CONTRACT CHANGE ORDER

CCO: 67 Suppl. No. 0 Contract No. 04 – 0120F4 Road SF-80-13.2/13.9 FED. AID LOC.:

Fabricate, ship and verify dimensions of a second tower base template and ship (4) field template parts, furnished by the Department to ABF on January 23, 2008, to China fabricated for Contract 04-0120E4 as described in this change order.

**SAN FRANCISCO OAKLAND BAY BRIDGE
EAST SPAN SEISMIC SAFETY PROJECT
SELF-ANCHORED SUSPENSION BRIDGE
(SUPERSTRUCTURE & TOWER)**

TOWER ANCHORAGE DETAILS NO. 9

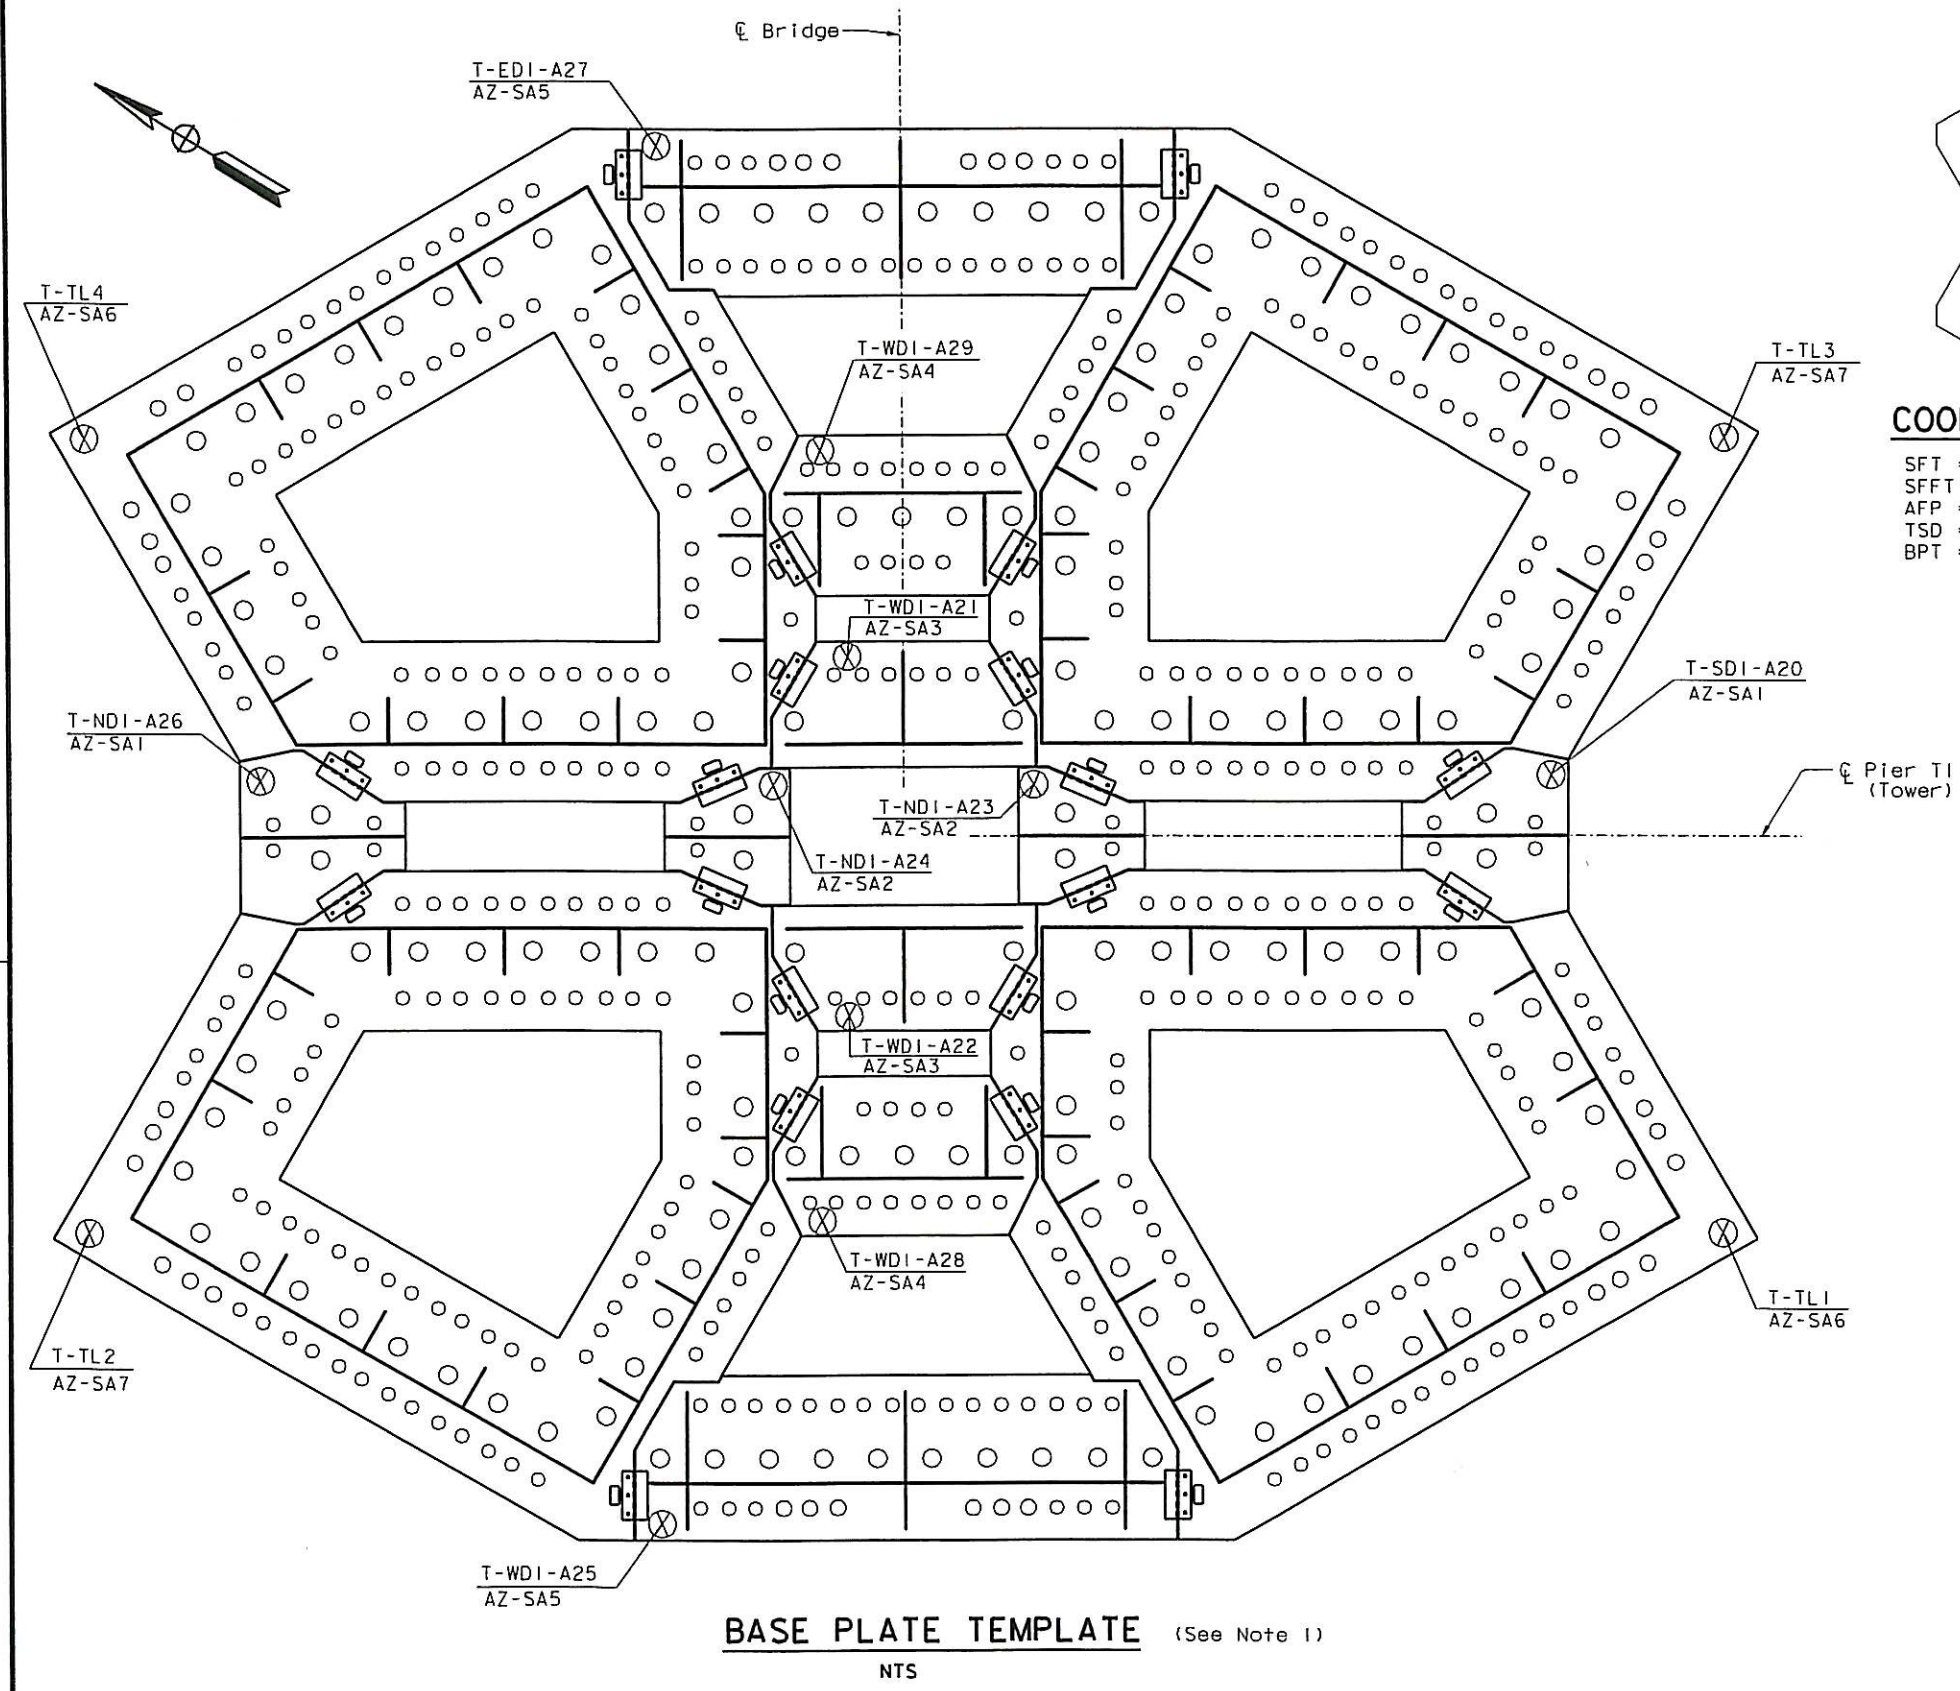
1. Ship Contract No. 04-0120E4 base plate field template parts to ZPMC in China to complete the State Furnished Steel Template previously furnished by the Department and described in Special Provisions Section 10-1.59, "Steel Structures," subsection "Template".
2. Fabricate a Second Tower Base Template using steel meeting the strength requirements of ASTM A709M Gr. 345 as shown on sheets three (3) through five (5) of this change order.
3. The Contractor shall verify the location of the holes by physically matching the Second Tower Base Template to the State Furnished Steel Template. This shall be witnessed by the Engineer.

The following revised sheets detail all changes:

Supplemental Contract Plan Sheet Nos. 600S1R1, 600S2R1 and 600S3R1 (of 1204).

- The flatness of the base plate template shall be within ± 5 mm of the overall X and Y dimensions of the permanent tower base plate.
- The base plate template shall be made of same number of pieces and configuration as the permanent tower base plates being erected as part of the permanent structure.

- The base plate template pieces shall be the same external size and shape as the permanent tower base plates.
- Holes in the base plate template shall be the same diameter as the holes in the permanent tower base plates.

- The holes in the base plate template shall be located to match the holes in the State Furnished Template and State Furnished Field Templates to within ± 3.0 mm.

- The reference lines on the State Furnished Template shall be marked on the base plate template within ± 1.0 mm.
- The tower Working Points (WP) at Elevation 3.125 m shall be marked on the punch plate for all tower shafts.

SAN FRANCISCO OAKLAND BAY BRIDGE
EAST SPAN SEISMIC SAFETY PROJECT
SELF-ANCHORED SUSPENSION BRIDGE
(SUPERSTRUCTURE & TOWER)
TOWER ANCHORAGE DETAILS NO. 11

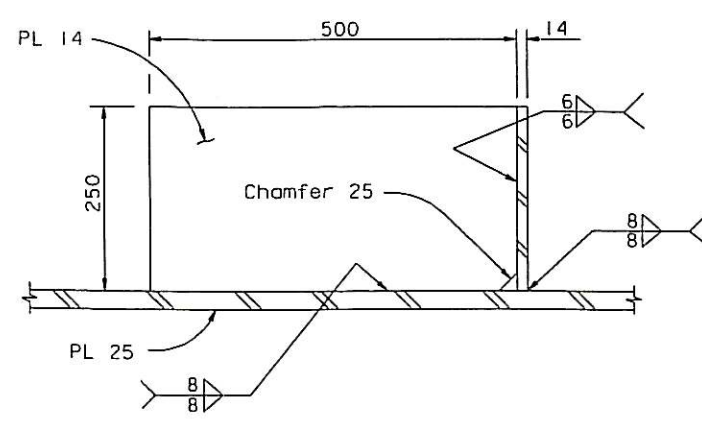
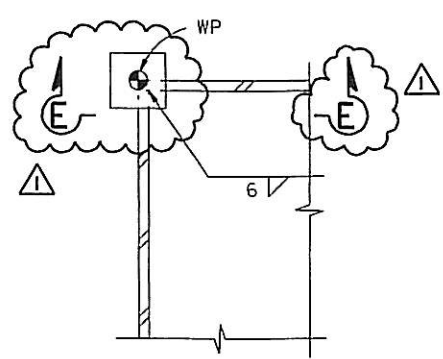
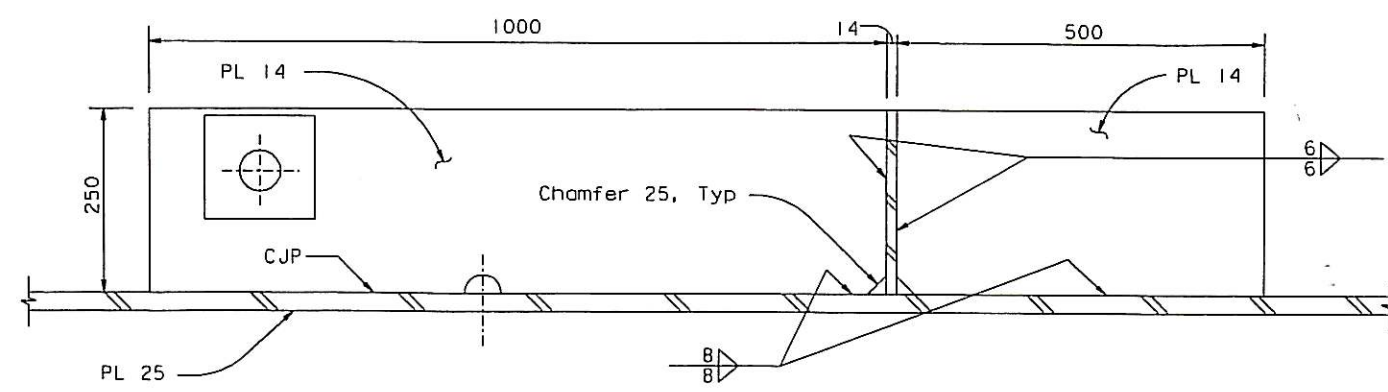
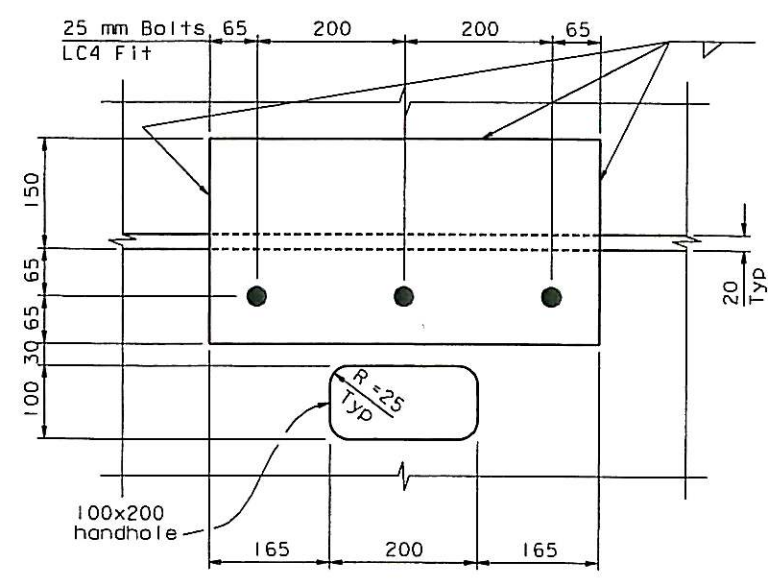
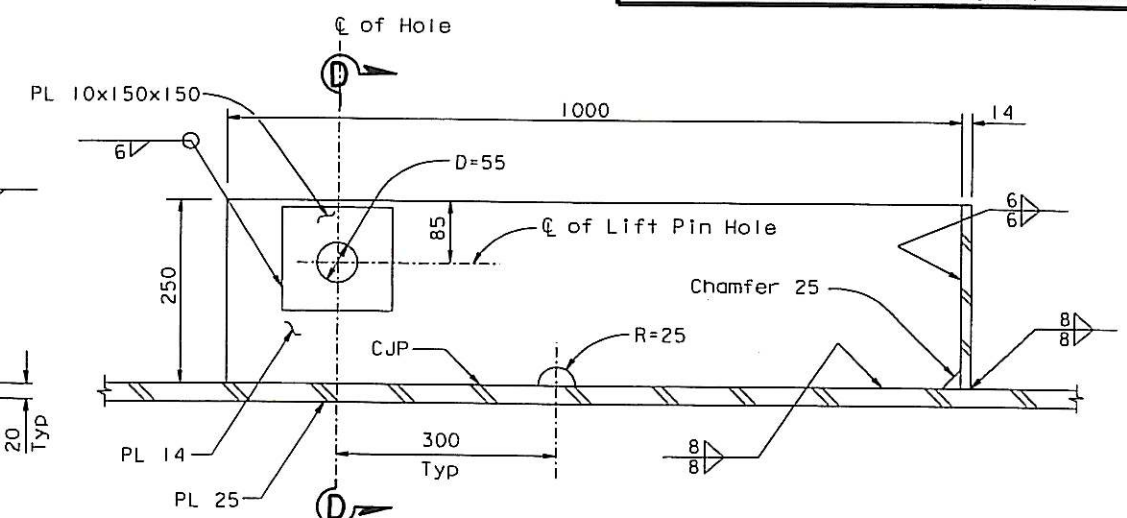
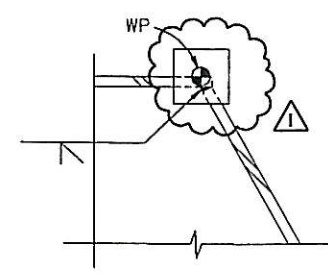
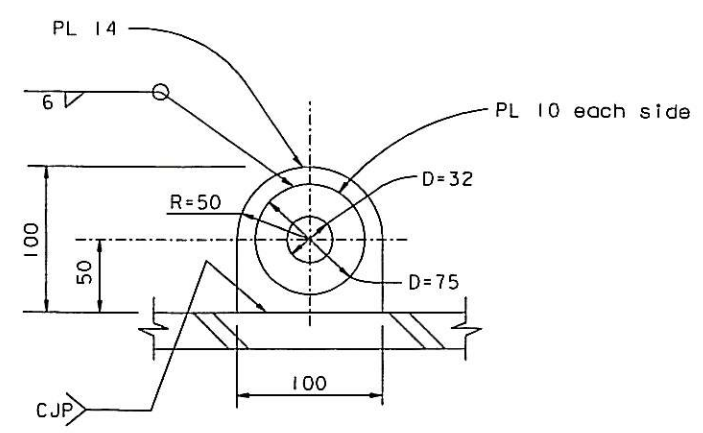
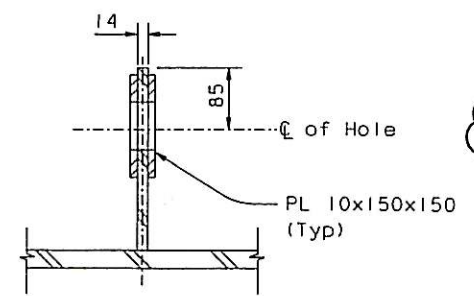
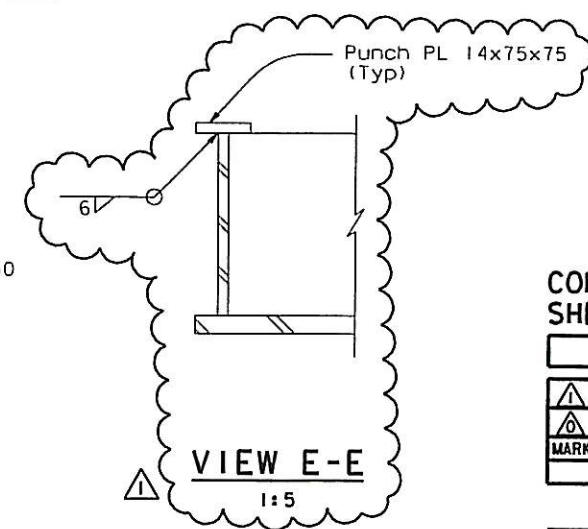
REQUESTS FOR INFORMATION NOT ADDRESSED IN THIS CCO REMAIN IN FORCE					
11/07/08	TOWER BASE PLATE TEMPLATE	JD	MN	67	
06/20/08	TOWER BASE PLATE TEMPLATE	JD	MN	67	
MARK	DATE	DESCRIPTIONS	BY	CH'D	CCO*
REVISIONS
